V2500-A1/A5/D5 SERIES PROPULSION SYSTEMS SERVICE BULLETIN

This document transmits the Initial Issue of Service Bulletin V2500-ENG-72-0568 and the Initial Issue of the Supplement

ENGINE – SEAL ASSEMBLY, NO. 3 BEARING – REPLACEMENT OF THE CARBON SEAL FOR IMPROVED
DURABILITY

NO. 3 BEARING REAR OIL SEAL ASSEMBLY
FIGURE 1

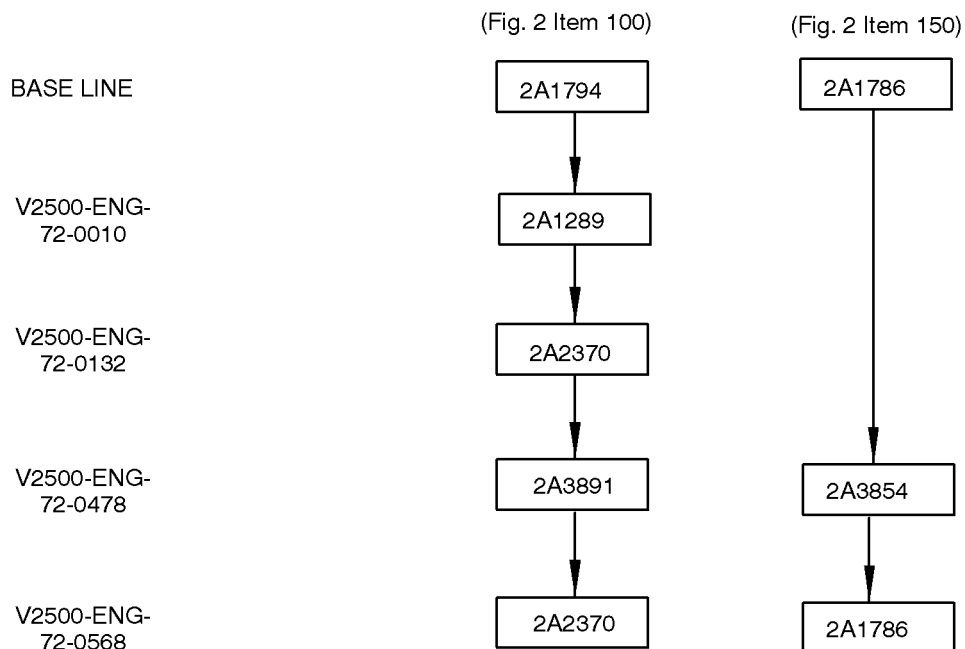
Replace the current No. 3 Bearing Seal Assembly with the prior configuration.

- (1) Remove the No. 3 bearing seal assembly from the front bearing compartment per:
 - (a) V2500-A1 Pre Service Bulletin ENG-72-0132 Engine Manual Subtask 72-32-20-040-052-A00.
 - (b) V2500-A1 Post Service Bulletin ENG-72-0132 Engine Manual Subtask 72-32-20-040-052-B00.
 - (c) V2500-A5 Service Bulletin ENG-72-0132 Engine Manual Subtask 72-32-20-040-052-C00.
 - (d) V2500-D5 Engine Manual Task 72-32-20-040-001, Subtask 72-32-20-040-052.
- (2) Disassemble the No. 3 bearing seal assembly per Engine Manual Subtask 72-32-25-040-051.
- (3) Replace the No. 3 bearing seal carbon detail per Engine Manual Task 72-32-25-300-007.

C. Assemble the No. 3 bearing seal assembly per Engine Manual Task 72-32-20-440-001.
